RE: JMC Project 20044  
4 Tripp Lane Zoning Compliance  
4 Tripp Lane  
Town of North Castle, New York

**Response to KSCJ Comments Outlined in a Memorandum Issued to the  
Conservation Board & Planning Board, dated February 15, 2024.**

PEREIRA RESIDENCE

Drawn: DK	Approved: AN
Scale: 1" = 20'	
Date: 03/01/2021	
Project No: 20044	
2004-SITE	TREE TREELS
Drawing No:	
C-130

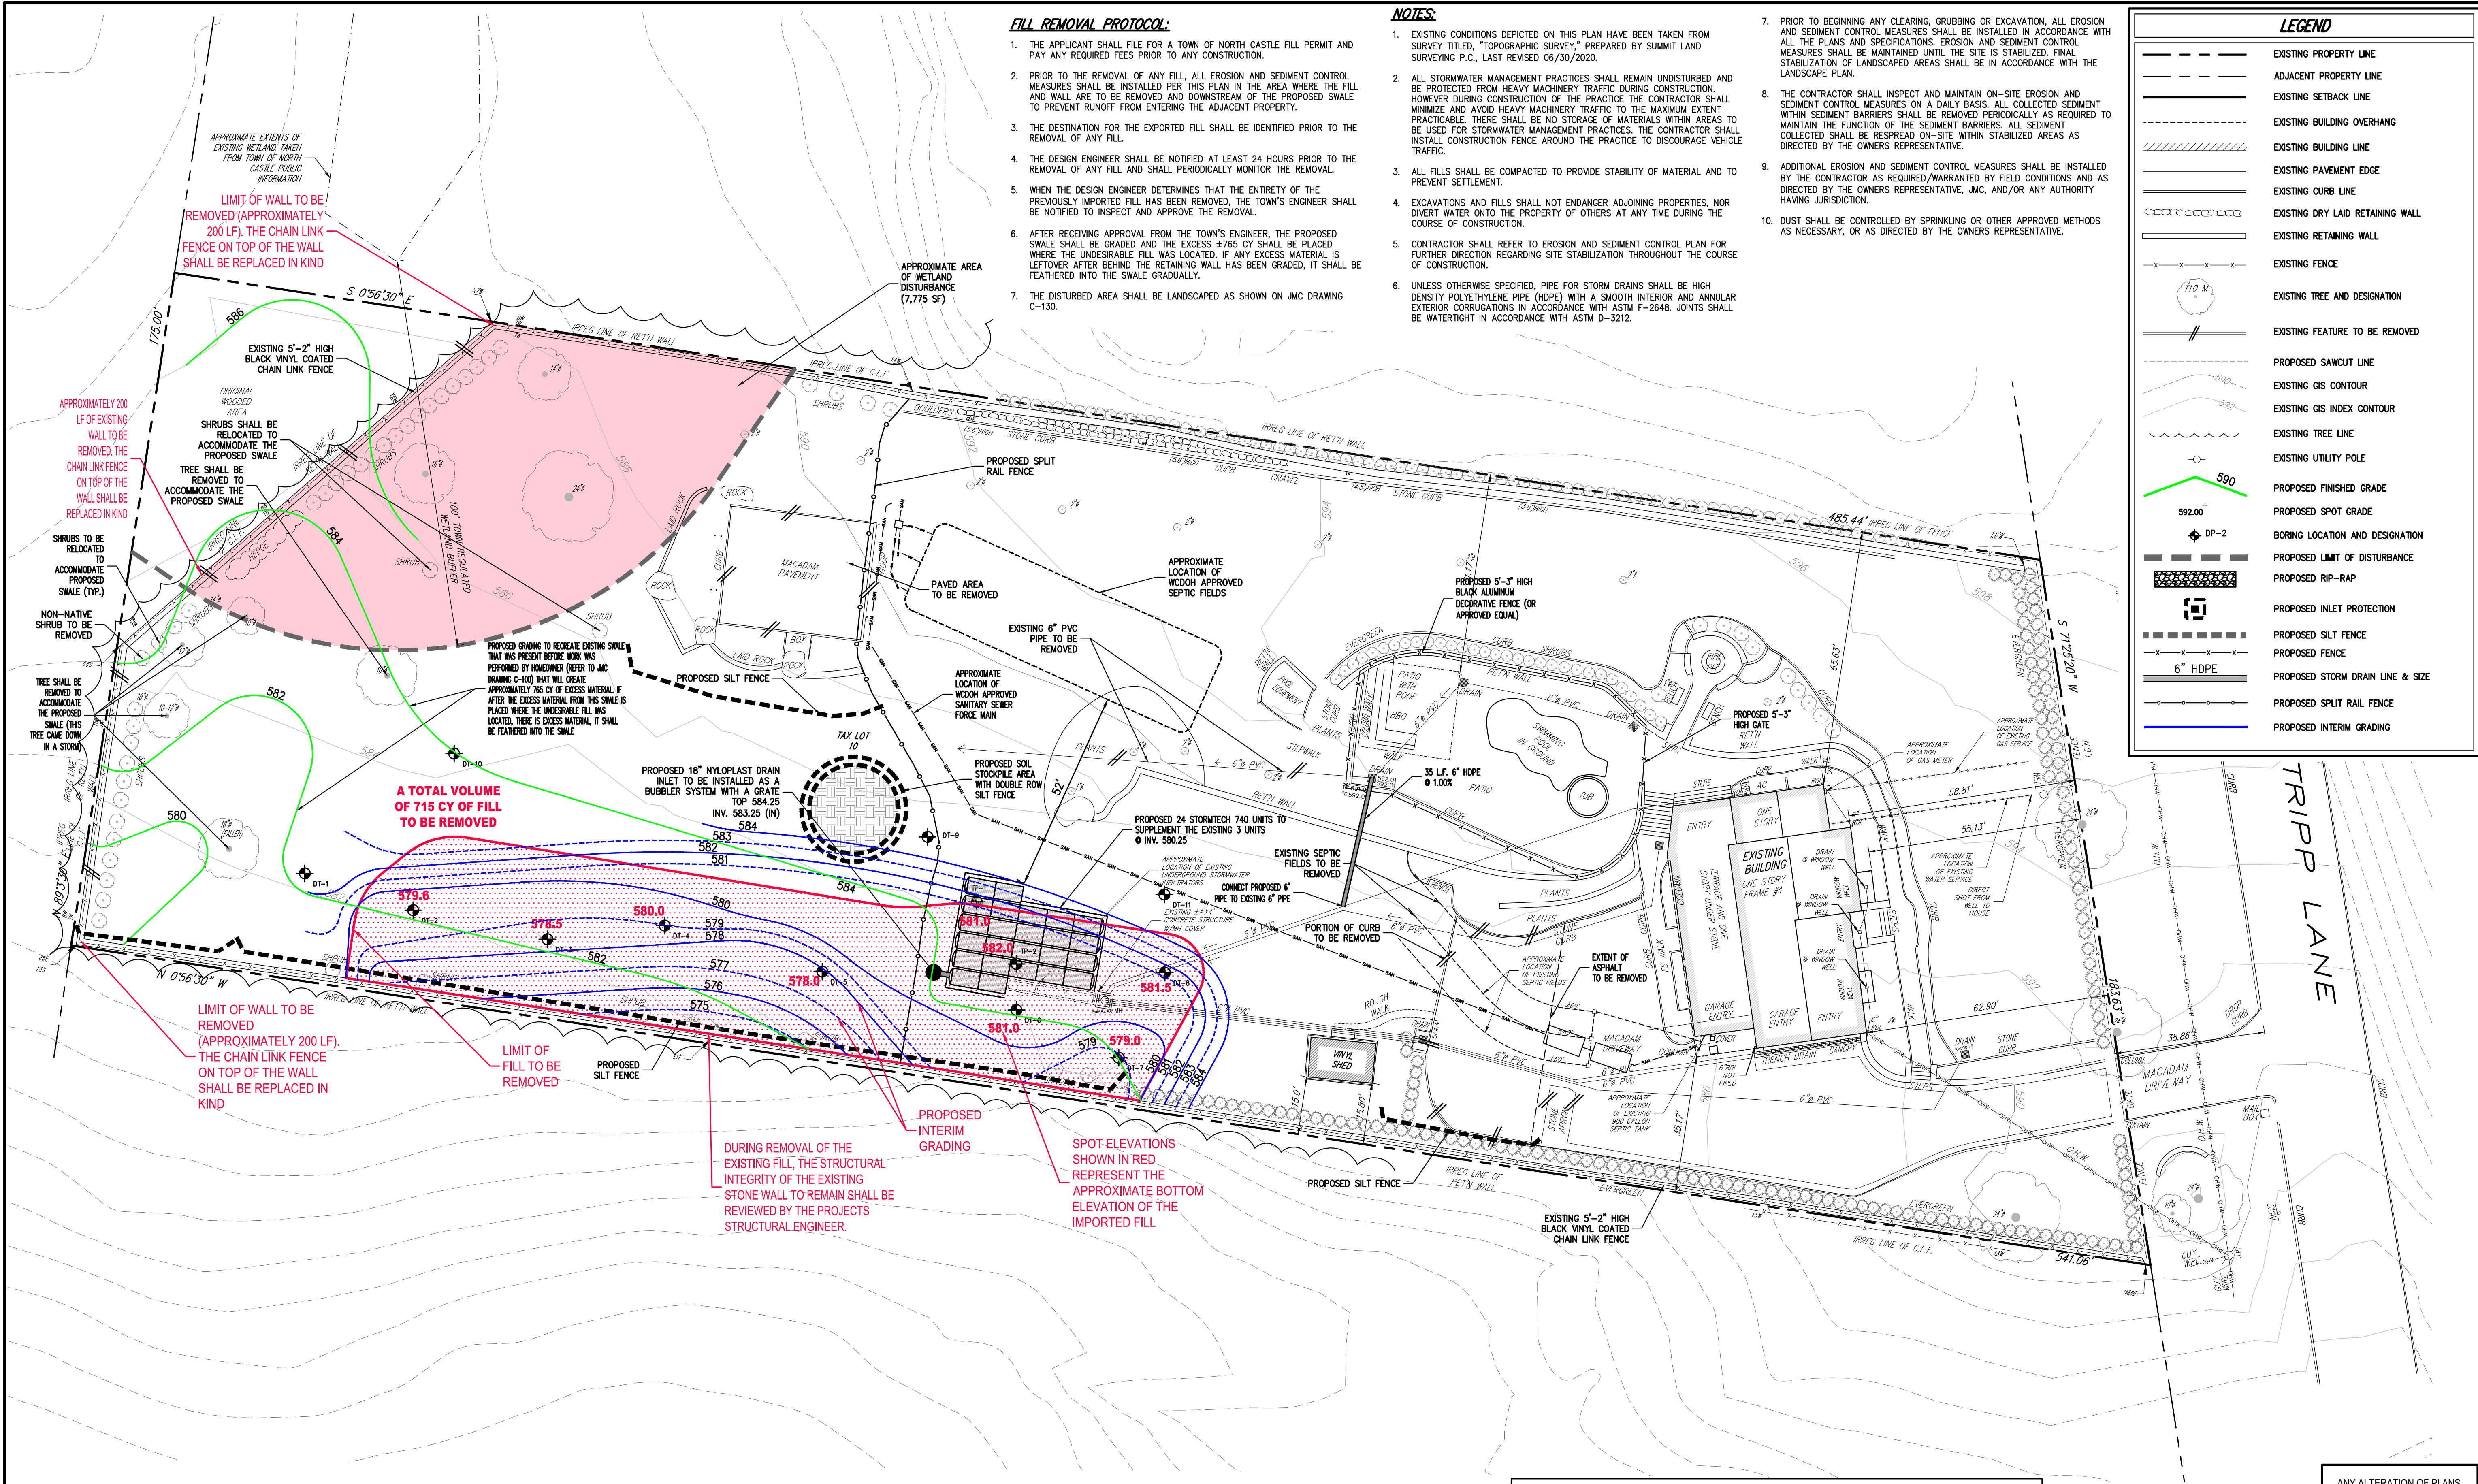
*As previously noted, the applicant has cleared a significant number of trees on the property. The quantity, size and species are not known. As required by Chapter 308, Trees of the Town Code, Section 308-25, the applicant will be required to provide a tree restoration plan to mitigate the unapproved removal of existing vegetation. The Planning Board will need to determine whether the restoration plan is ultimately appropriate for the level of disturbance and removals.*

*Because the actual level of Town-regulated tree removal is unknown, the applicant has used the adjacent property to establish a tree sample area to establish a baseline for the tree mitigation calculations. This office is amenable to this approach. The applicant has identified all trees greater than eight (8) inches in diameter and all trees greater than 24 inches in diameter from the 5,000 sf tree sample area. A total of 17 trees were sampled; 13 @ 8 inch dbh or greater and 4 @ 24 inch dbh or greater, which equates to 76% and 24% of the sample area, respectively. Applying this sample area over the  $\pm 1.15$  acres of tree removal results in a total of 171 trees removed; 130 @ 8 inch dbh or greater and 41 @ 24 inch dbh or greater (not 139 and 32 as presented in the calculations). This results in a minimum total tree caliper of 2,024 inches to mitigate. The applicant is proposing a total of  $\pm 146$  caliper inches of plantings. The applicant shall update the mitigation requirements, proposed tree planting notes and planting plan accordingly. It appears additional mitigation will be required. The planting notes were also cut off on the plan and should be corrected.*

JMC submitted and presented Drawing C-130, titled "Tree & Wetland Mitigation Plan" to the Conservation Board following two separate site walks, one including a representative from the Conservation Board the other including a representative from KSCJ, that now shows the updated wetland location and subsequent tree and wetland mitigation plan as determined following these site

It seems the applicant, the Planning Board, and the Conservation Board are in agreement that a total of 2,024 DBH inches were removed during the construction detailed on these Site Plans and would require the planting of 2,024 DBH inches to mitigate the removal. The mitigation, as shown on JMC Drawing C-130, is detailed below:

- 8-18" DBH trees were saved. (144 inches)
- 238-2" DBH trees were planted. (476 inches)
- 9-8" DBH trees were also planted. (72 inches)
- 29-3.5" trees are proposed to be planted. (101 inches)
- 23-1" trees are proposed to be planted. (23 inches)

**For a total of 816 inches of tree mitigation.** This was the amount that was described to the Conservation Board, and it was the applicant's understanding that their approval, detailed in the March, 7<sup>th</sup> letter, included this mitigation amount. It should be noted that the applicant proposes to dedicate 31,200 sf as a "no mow" meadow area.

Drawn: **DK** Approved: **AN**  
Scale: **1" = 20'**  
Date: **03/25/2024**  
Project No: **20044**  
2004-SITE WALL SITE.ecr  
Drawing No:  
**C-140**

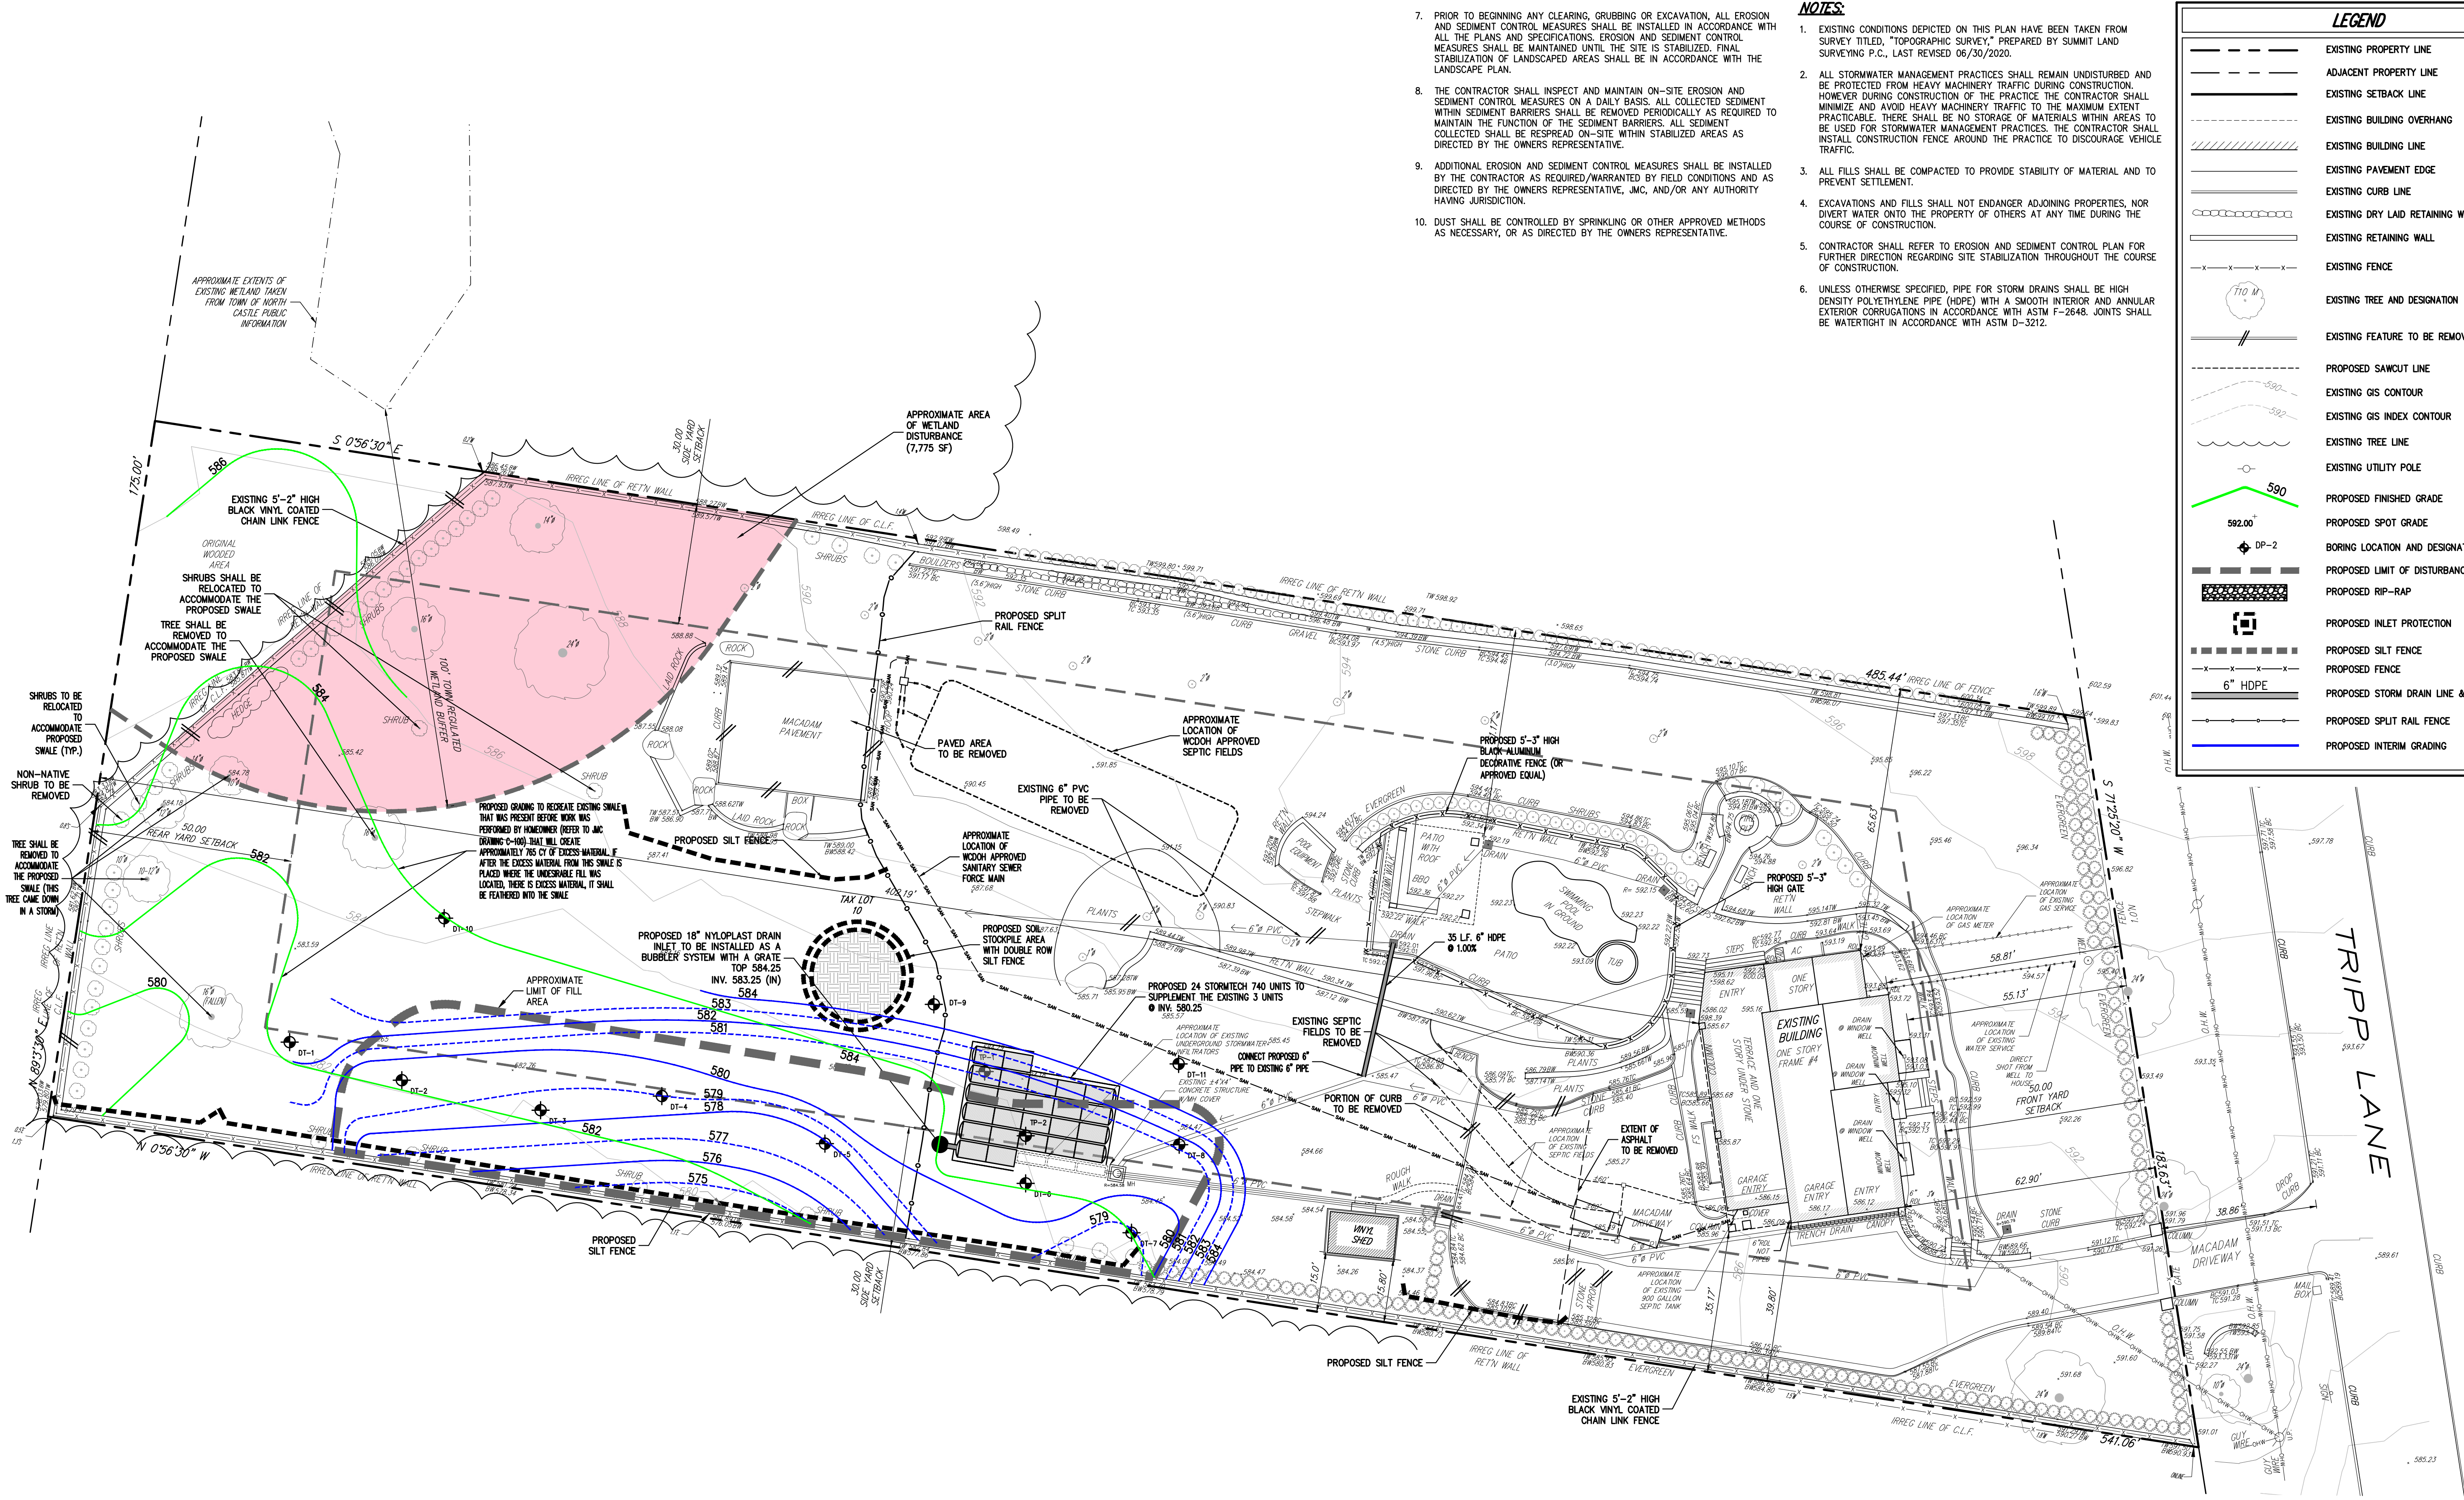
*As previously requested, the cut and fill plan should overlay the surveyed topography onto the pre-developed GIS topography to illustrate the cut and fill volumes established between pre-existing conditions and existing conditions. The fill sampling and testing was reviewed by the Town's Environmental Consultant. It was agreed that the fill remain in place with a 24 inch soil cap and a demarcation layer (orange fence or geotextile membrane) placed above the existing fill section. The soil cap shall include a minimum six (6) inch layer of top soil. This has been noted and detailed on the plan. However, the applicant shall prepare a proposed grading plan to illustrate how the add fill will be accommodated on the site and what, if any, added modifications to walls, walks, drives, etc., may be needed as a result. The applicant must also prepare an erosion and sediment control plan to illustrate and detail temporary access to the site and protection of the septic field for the import of clean fill, as well as all temporary sediment and erosion control measures that will be required.*

***The applicant has revised the scope of the project to propose the removal of approximately 704 c.y. of imported fill, which appears after extensive testing on the site, concentrated in an area located along the western property boundary. The applicant has stated, during a meeting on August 6, 2023 held at Town Hall, between the Applicant, The Planning Department, and our office, that test pits have revealed that the imported fill did not extend to the rest of the site as originally assumed. We defer to the Board on the acceptance and limits of the new imported fill removals.***

As was requested at the last Planning Board meeting on March 11<sup>th</sup>, the applicant has prepared a fill removal plan, titled "Fill Removal Plan" that would detail how the Site would look in the interim while the fill was removed before the excavated area could be backfilled.
